AGENDA CITY OF KENTWOOD PLANNING COMMISSION TUESDAY, NOVEMBER 9, 2021 KENTWOOD COMMISSION CHAMBERS 4900 BRETON AVENUE 7:00 P.M.

PROPOSED MINUTES OF THE REGULAR MEETING OF THE KENTWOOD PLANNING COMMISSION OCTOBER 26, 2021, 7:00 P.M. COMMISSION CHAMBERS

STAFF REPORT:	October 22, 2021
PREPARED FOR:	Kentwood Planning Commission
PREPARED BY:	Lisa Golder
CASE NO.:	34-2021 Union at Silver Station Apartments Site Plan Review

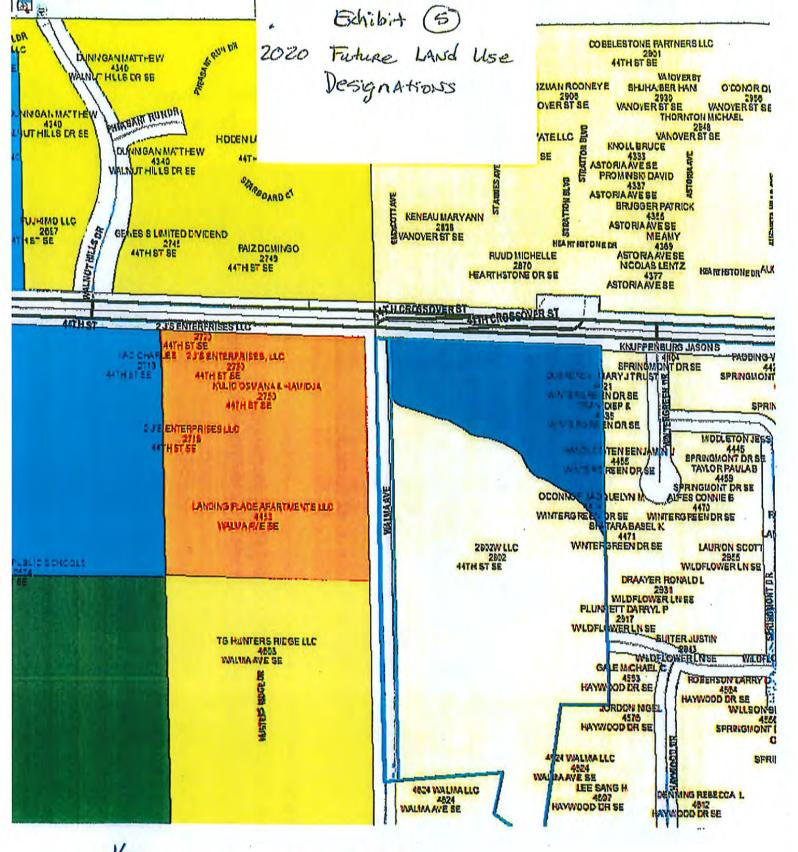
- 7. Exhibit 10 portrays the gross units per acre for developments in the immediate vicinity of the subject property. The Wildflower Estates Plat and Woodhaven Condominium numbers reflect their net units per acre.

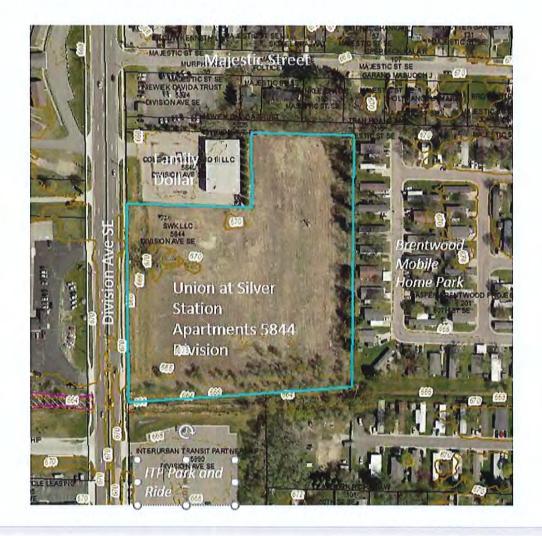
- 12. The proposed development includes a clubhouse (within Building B), a dog park, a playground, and an "amenity space". The applicant shall detail what is included in the amenity space and playground. With 28 three bedroom apartments, there are likely to be a number of children living within the development; the location of play area/open space is limited within the development.

- 13. The applicant should relocate the dumpster that is in front of Building F.
